Packard **SERVICE TECHNICAL**
Bulletin

50T-44

Subject: HIGH SPEED VIBRATION - MODEL 200

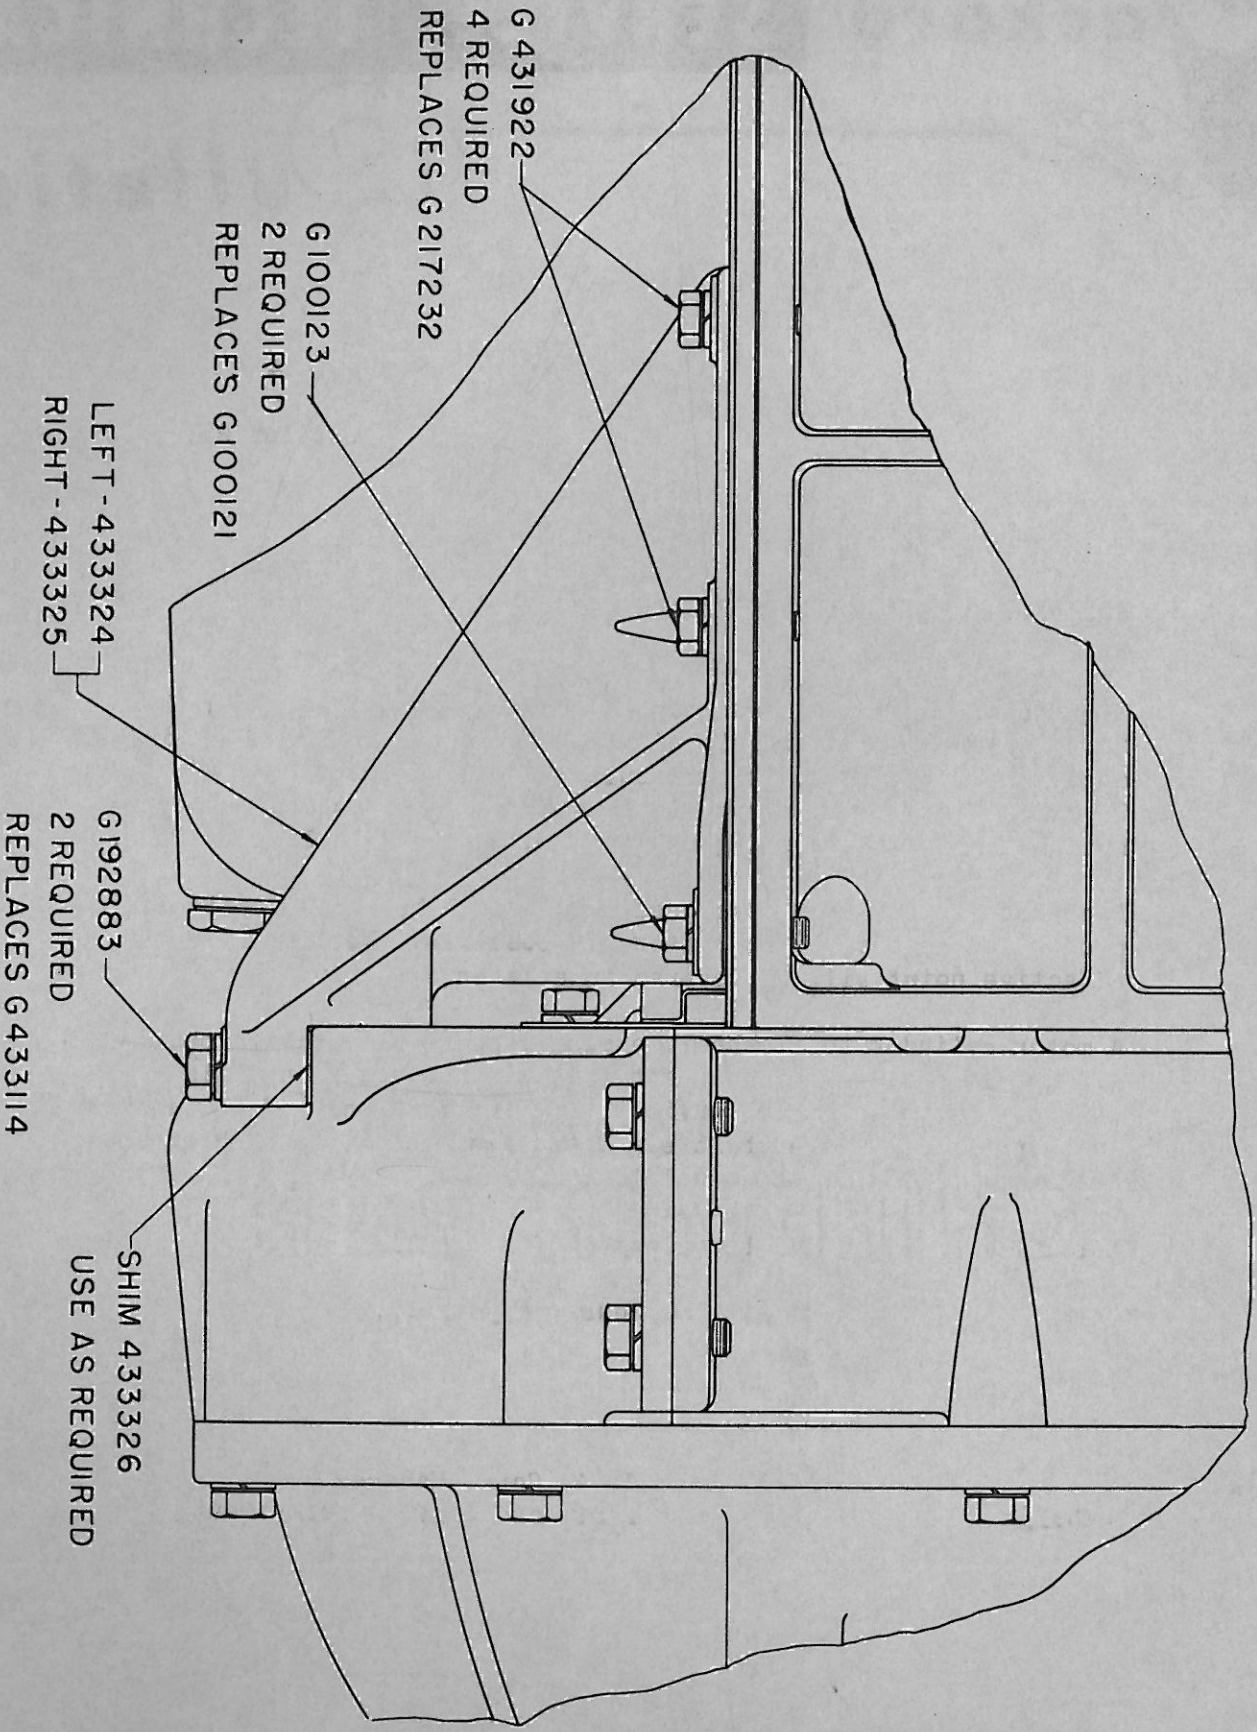
High speed motor vibration may be reported occasionally on the 24th Series 200 model equipped with Ultramatic Drive. The disturbance, when it exists, is particularly noticeable between 80 and 90 miles per hour. In some instances, a disturbance also may be noticeable to a lesser degree at speeds below 80 miles per hour.

A motor cylinder to flywheel housing support kit, part number 436059, is available to correct this disturbance when it is reported on vehicles in service. An initial supply of these kits is being shipped to each Zone. Details of the kit are shown on the reverse side of this bulletin.

G 431922
4 REQUIRED
REPLACES G 217232

G 100123
2 REQUIRED
REPLACES G 100121

LEFT - 433324
RIGHT - 433325

G 192883
2 REQUIRED
REPLACES G 433114

SHIM 433326
USE AS REQUIRED
